Issue 1 - Junction design at optioneering stage

In Deadline 5 (D5) Submission - 8.26 Comments on Responses Received by Deadline 4¹ Highways state the details the assumptions that were applied to both Option 12 and Option 30. This document I believe was published after the Public Consultation. I believe the A417 Consultation Brochure showed the 2 options to the members of the public as:

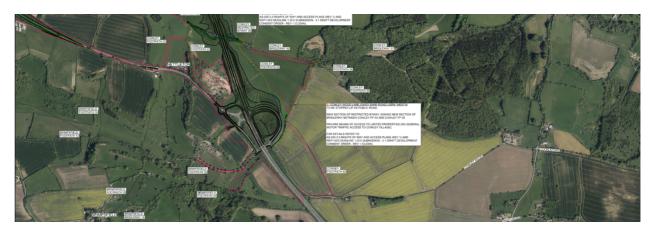
Image taken from A417 Consultation Brochure, showing the 2 route options that were presented at the time of the Public Consultation in 2018. Clearly there is no junction at the Cowley Roundabout for Option 30, and Highways state that this was *for engineering reasons related to level differences and geology.*

I think it is clear from the above that *level differences and geology* were not reasons for omitting a junction at the Cowley Roundabout at the time of the Public Consultation, as the current Option 30 has a junction in the same location as that for Option 12.

Question: Put simply, can the ExA be appraised <u>again</u> as to why Option 12 had a junction at Cowley Roundabout in the design put forward <u>for the Public Consultation</u>, whilst it was assessed that Option 30 did not require it. The Applicant's response to the previous question has not provided a credible response as it relates to after the Public Consultation – Section 6.7 of the SAR (Document Reference 7.4, APP-420). The ExA must now seriously question whether at the time of Public Consultation, Highways descoped the design for Option 30 to keep the cost of the Option within the estimated cost range of 250 - 500 million. Highways have been given the opportunity to explain why, but they have clearly contradicted themselves in their latest response - *level differences and geology* clearly were not the reasons.

Question: Can the ExA be appraised as to whether at the time of the consultation, if the junction layouts had been of similar number and design, would the monetised costs and benefits of both options have been more similar or even in favour of Option 12?
